MEMORANDUM

From:	Built Heritage Officer		
Service	Green Infrastructure	App No:	242252 + 242253
Address:	Moat House, Biggs Lane, Arborfield, RG2 9LN.		
Proposal:	242252: Full Planning Permission for the change of use of the Moat House building from office (Use Class E) to residential (Use Class C3) to provide 4no. residential dwellings and associated internal roads, parking, landscaping, drainage, plant, bin, and cycle storage. 242253: Application for Listed Building consent for the proposed change of use of the Moat House building from office (Use Class E) to residential (Use Class C3) to provide 4no. residential dwellings and associated internal roads, parking, landscaping, drainage, plant, bin, and cycle storage.		
Heritage Asset:	Moat House – grade II listed building since 2014. Moated site north of Moat House – Schedule Ancient Monument. Listed Buildings and Scheduled Monuments are classed as designated heritage assets under the NPPF (2023) and in the Council's Local Plan policies.

Existing Plans showing demolition works in red. Blue circled areas being masonry walling nibs expected to be retained.

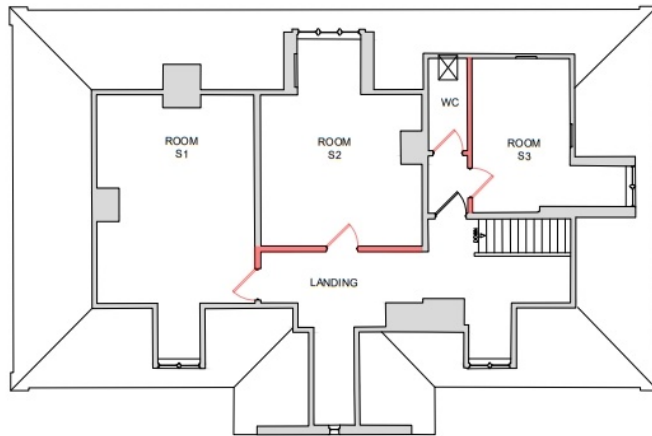
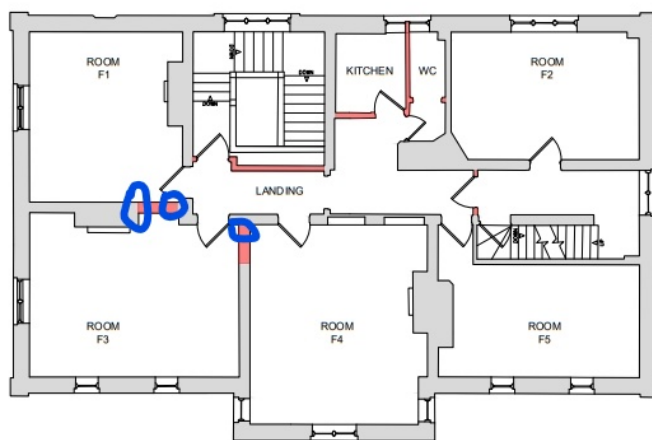
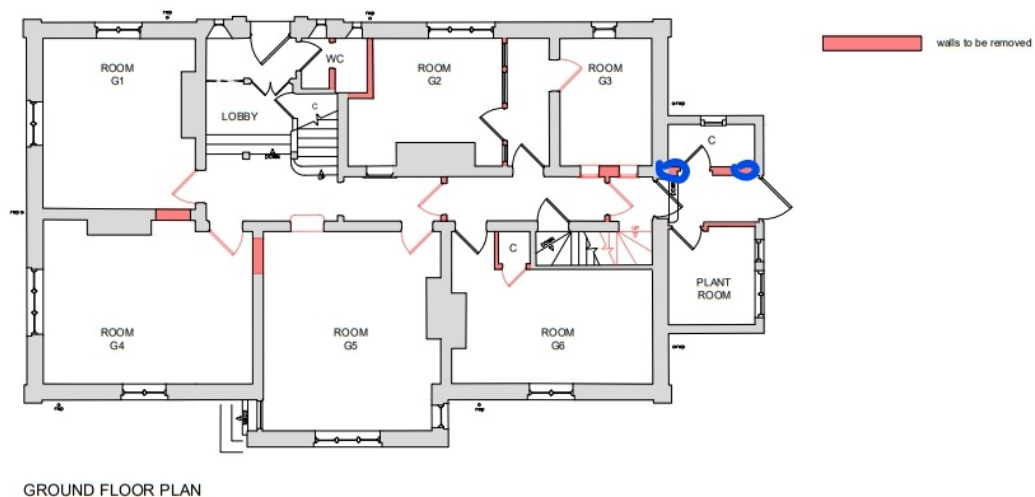
The other issue that it is considered needs addressing is the matter of retaining masonry wall nibs as evidential indication of the original layout of walls in those locations where new openings are to be formed on the first floor and to the kitchen to apartment 2 where an internal masonry wall is to be completely removed.

between rooms are to be formed wall nibs are kept, these are not replicated on the proposed first floor plans. Ensuring the retention of masonry wall nibs where opening between rooms are being formed and where walls are to be removed provide are considered to be important visual indicators of the historic planform of the building. As such, there is the expectation for the proposed floor plans to be amended accordingly.

Notwithstanding the details submitted, where internal walls to be removed and/or new door openings to be formed under this hereby approved scheme, masonry nibs are to be retained, including in the case of new door openings to be formed beside a room fireplace build-out, a small section of the dividing masonry room wall be retained as a 'nib' along with a matching masonry wall nib where the walling dividing the former rooms bisects with the walling of the corridor/hall, unless otherwise agreed in writing by the local planning authority prior to changes being made to the walling.

Proposed Ground & First Floor = blue circles mark location where masonry wall nibs are expected to be retained to delineated historic planform configuration. The yellow encircled element is considered to be an awkward and undesirable intersection of new walling with window (enlarged view below)

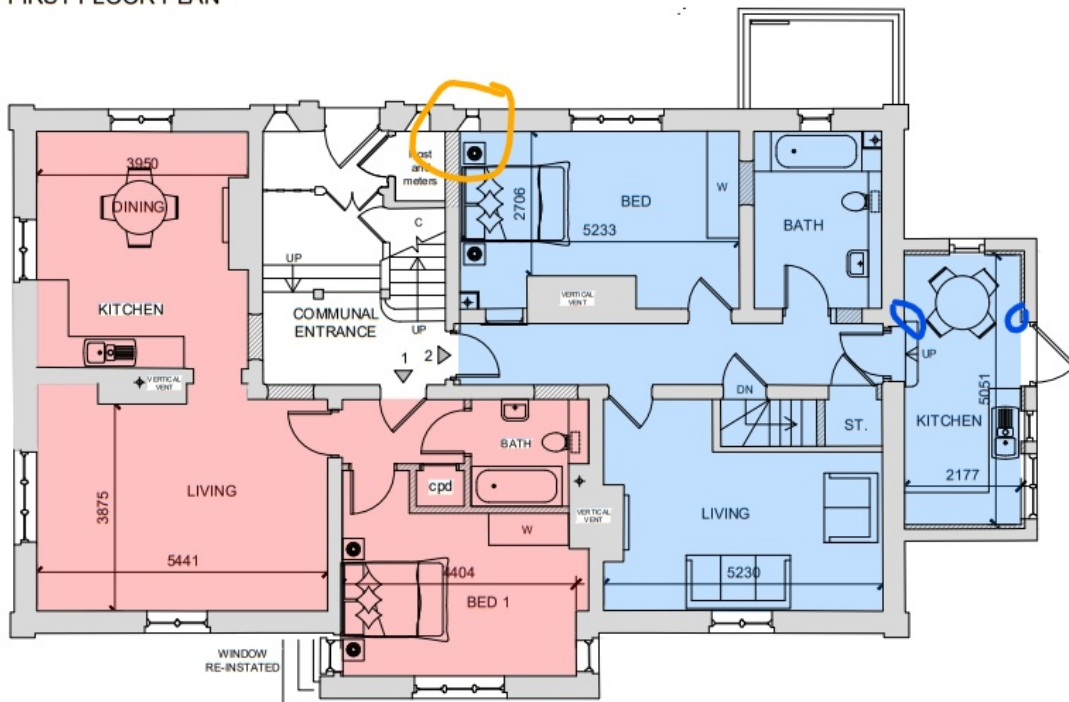
That said, there are elements as proposed, which it is advised require amending in order to better reveal historic elements and to improved evidence of the building's former historic internal layout. To that end, on the ground-floor where there is to be alterations made to the small room off the entrance lobby where new walling is to be introduced to square-off the wall to bedroom to apartment 2's bedroom. This is considered to be a poor arrangement and partially obscure the opening reveal to the lancet window in the exterior wall. It is recommended that the new walling intersection with the exterior wall is amended so as to ensure it does not overlap the window reveal and sufficient space between the wall and window reveal to given to protect the legibility of that window from inside.
